Savannah Environmental (Pty) Ltd

SITE LAYOUT PLAN DEVELOPMENT

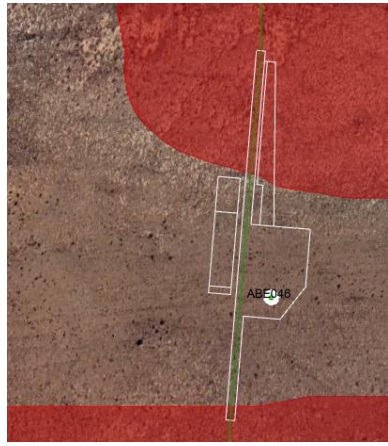
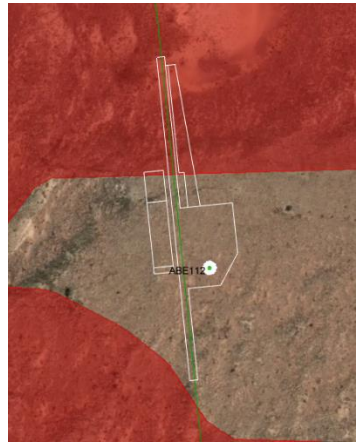
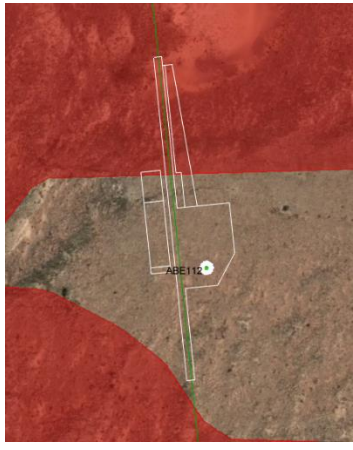
| Version # | Date | Informant Constraints | Comments | | | | | | | | |
|---------------------------|---|---|--|-----------|----|-----|-----|--|---|---|---|
| Preliminary Layout | | | | | | | | | | | |
| 1 | October 2020 | Lease areas | Boundaries of the lease areas as defined and agreed to with affected landowners | | | | | | | | |
| | | Desktop wind resource | Desktop wind resource data informed the optimum turbine placement | | | | | | | | |
| | | Avifaunal screening | An avifaunal specialist was appointed to conduct an initial site survey and report on any key priority species nesting within the project or neighbouring properties which may require buffering out large portions of the proposed project site. N | | | | | | | | |
| 2 | February 2021 | Met mast location | Suitable locations for the measurement masts were modelled based on the preliminary layout (Version#1) | | | | | | | | |
| 3 | March 2021 | Increase in turbine size to 120 | Considering the extent of upstream strengthening required need sufficient scale | | | | | | | | |
| 4 | September 2021 | Amendment to met mast locations | Following a site-visit undertaken by the resource technical team in May 2021, alternative measurement mast positions were identified. This had knock-on effects on the preliminary turbine layout which needed to be remodelled. | | | | | | | | |
| | | Avoidance of aquatic buffers | Refined aquatic buffers were available at this point and were considered in this iteration. | | | | | | | | |
| Draft BAR Layout | | | | | | | | | | | |
| 5 | July 2022 | Specialist constraints available at the time | All verified specialist constraints were available at this stage, except for avifauna, bats and ecology which at the time was pending further monitoring and/or verification. | | | | | | | | |
| | | 1 yr verified wind data | At the time, the project resource team had completed a year of the wind measurement campaign. The data obtained up to this point informed optimised turbine placement. | | | | | | | | |
| 6 | August 2022 | Final bat constraints | Based on 12-month monitoring campaign and sensitive feature verification | | | | | | | | |
| 7 | October 2022 | Final avifaunal constraints | Based on 12-month monitoring campaign and collision-risk modelling | | | | | | | | |
| 8 | November 2022 | Micro-siting of turbines 13, 46 and 112 outside of no-go areas | <table border="1"> <thead> <tr> <th>Turbine #</th> <th>13</th> <th>46</th> <th>112</th> </tr> </thead> <tbody> <tr> <td></td> <td></td> <td></td> <td></td> </tr> </tbody> </table> | Turbine # | 13 | 46 | 112 | |  |  |  |
| | | | Turbine # | 13 | 46 | 112 | | | | | |
| |  |  |  | | | | | | | | |
| | | | | | | | | | | | |

| | | | Design Recommendation | Shift all infrastructure 18 m NW | Shift all infrastructure 130 m W OR Reflect and shift upwards | Shift 90 m S OR Reflect and shift upwards |

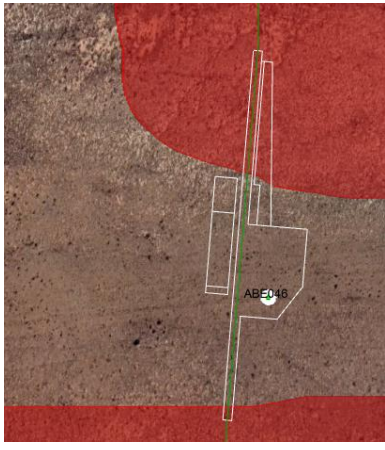
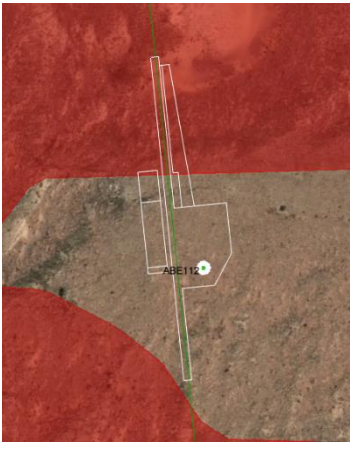
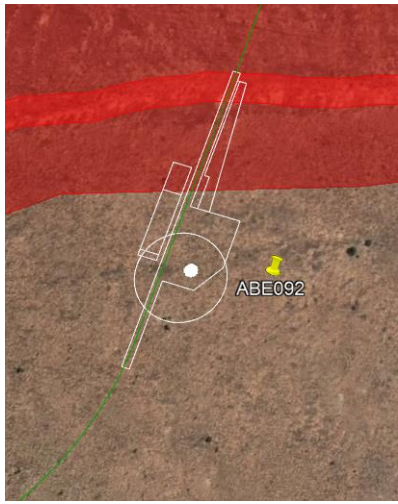
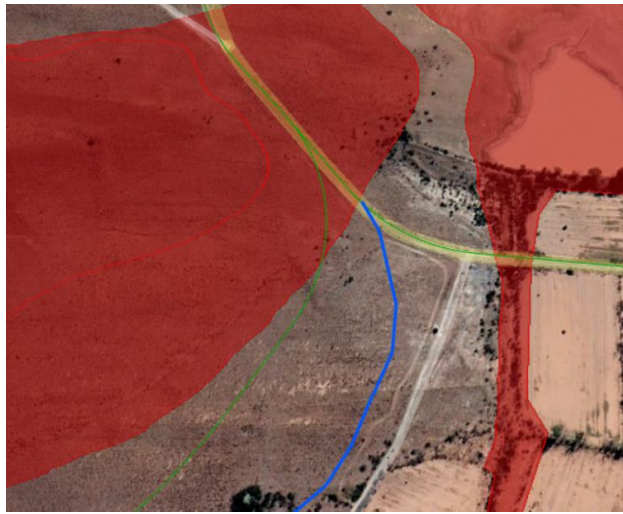
| 9 | November 2022 | Micro-siting of turbine 92 and re-alignment of a portion of access road | Turbine # | Turbine 13 | Access Road | |

| | | | Design Recommendation | Reflect the hardstands so as to remove the blade assembly area from the drainage line | <p>A portion of the new access road (green) was microsighted outside of an ecological high sensitive area (blue).</p> <p>Any widening of an existing roads within ecological high sensitive areas (as above) is deemed acceptable by the ecologist:</p> <p><i>“Yes, it is preferable to use the existing roads even where these traverse the sensitive areas. There may be one or two sites where this may be an issue, but I doubt it.</i></p> <p><i>So yes, it is ok to have the roads widened to 6m in these areas.”</i></p> | |
